TECHNICAL SERVICE BULLETIN

72 B 5

Alternator Control Relay
Type 16RA

Stag

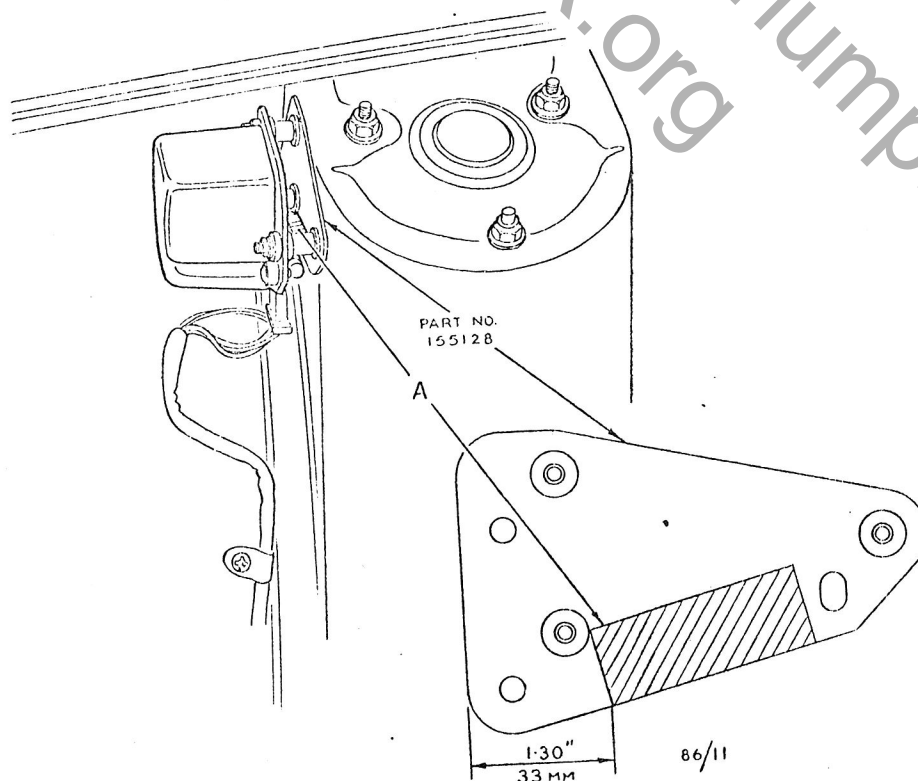
Due to the flexibility of mountings used for attaching the alternator control unit to the right-hand front suspension turret, the unit can be damaged by an electrical short-circuit.

Excessive downward pressure applied to the top of the control unit can cause a resistor which is attached to the rear of the unit, to contact its mounting plate and so cause an electrical short.

To avoid this possibility, please attach a strip of suitable tape to the mounting plate (as shown in the accompanying diagram) during pre-delivery and/or subsequent scheduled servicing periods.
